U.S. Consulate General, Karachi

- 1) Walls and roof have evident seepage/leakage.
  - i) When was water/roof-heat proofing conducted?  
Roof treatment was done 6 years ago.
  - ii) If seepage occurred prior or after the waterproofing.  
Seepage occurred after waterproofing.

FRONT ELEVATION

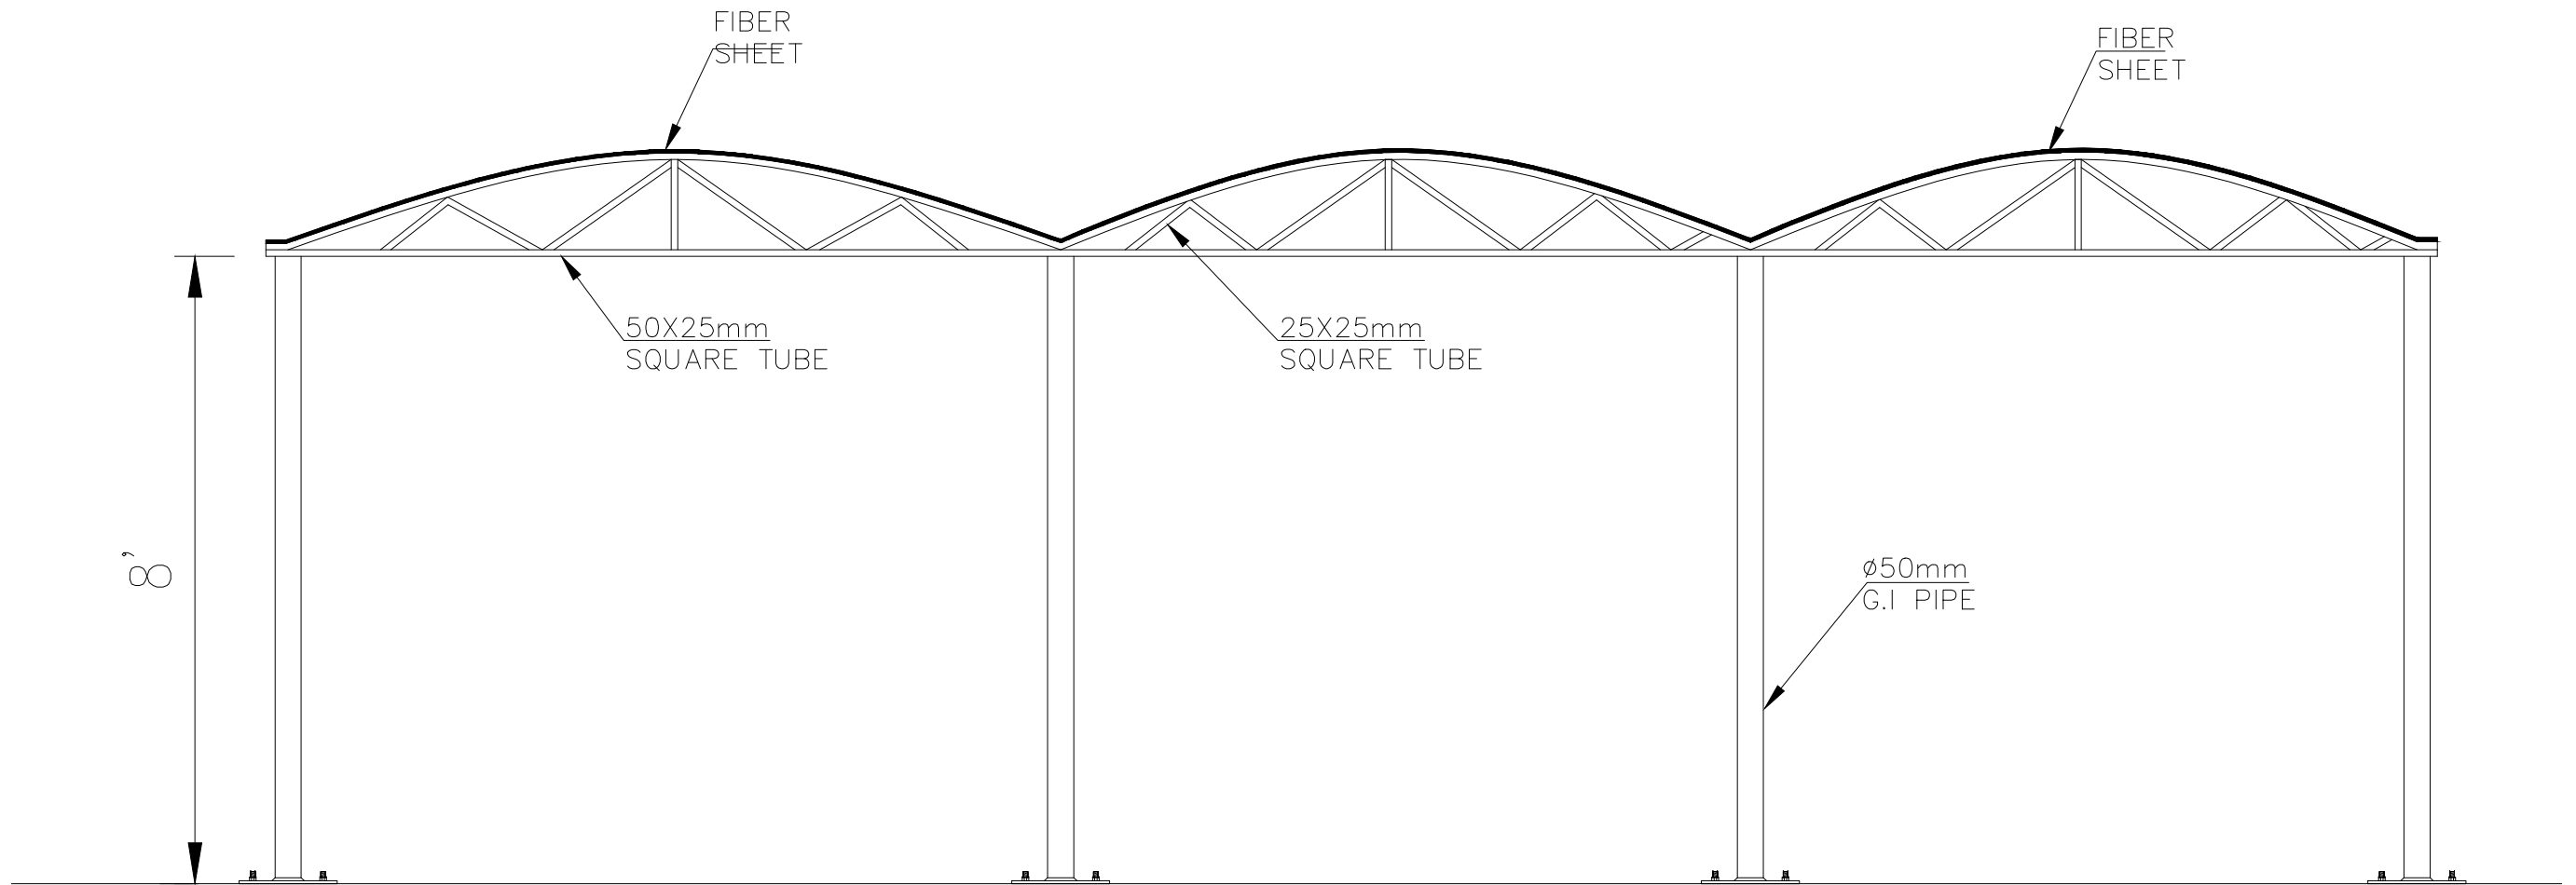
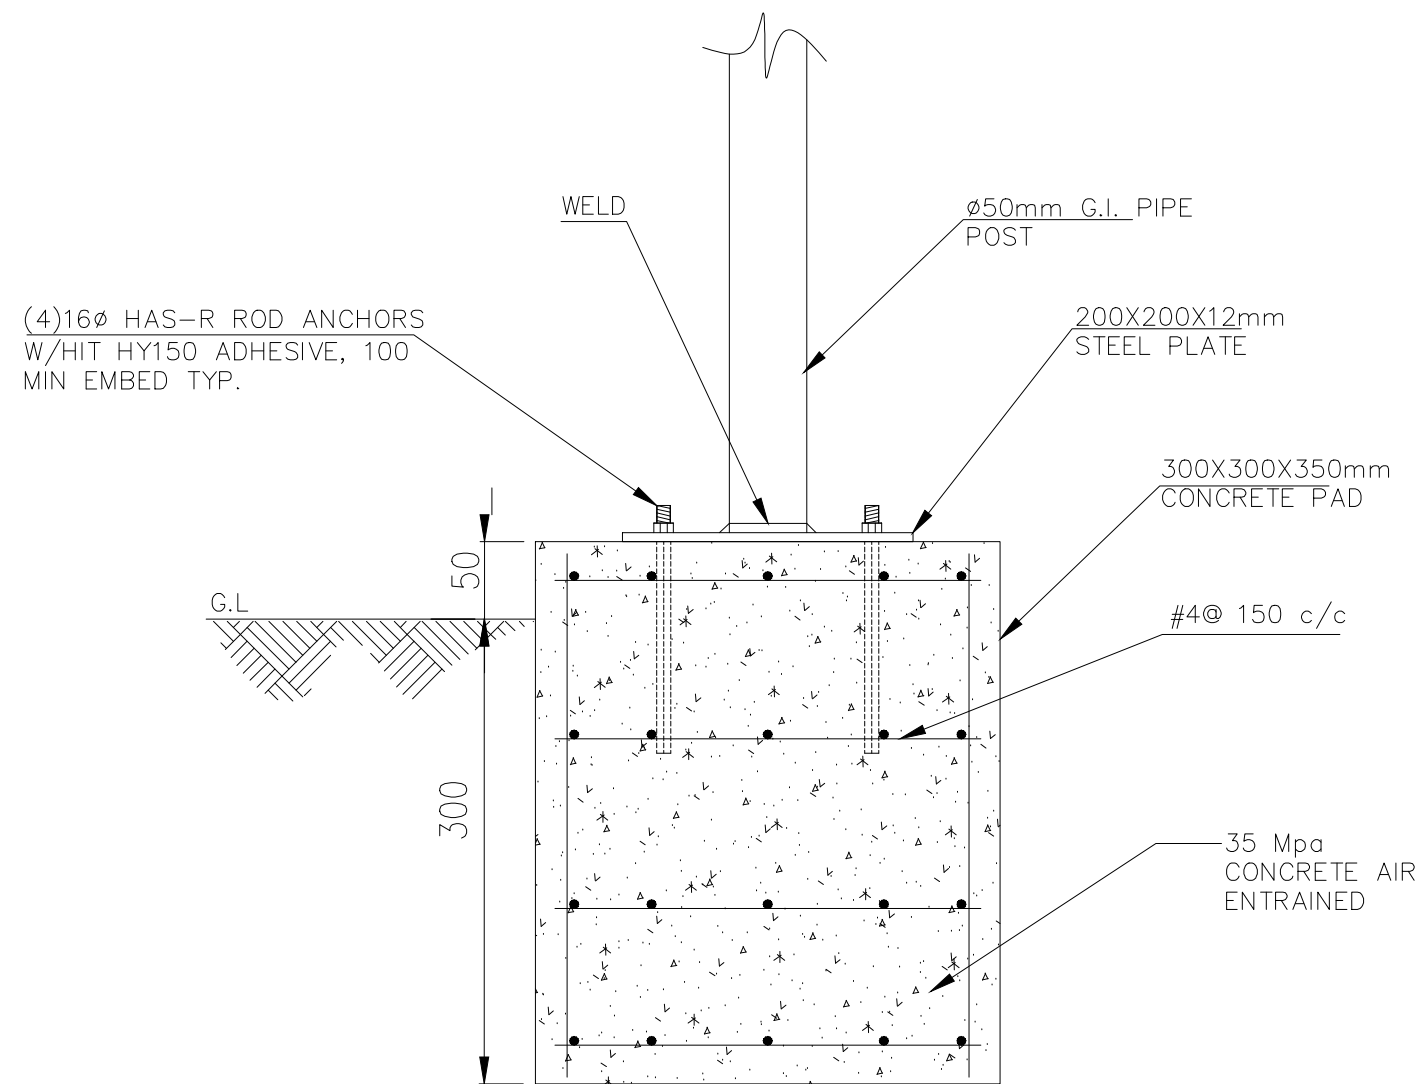
- 5) If one company is awarded both projects, do they start them simultaneously.  
Yes.
- 6) Share drawing/measurement of parking area shade.  
Drawing attached.
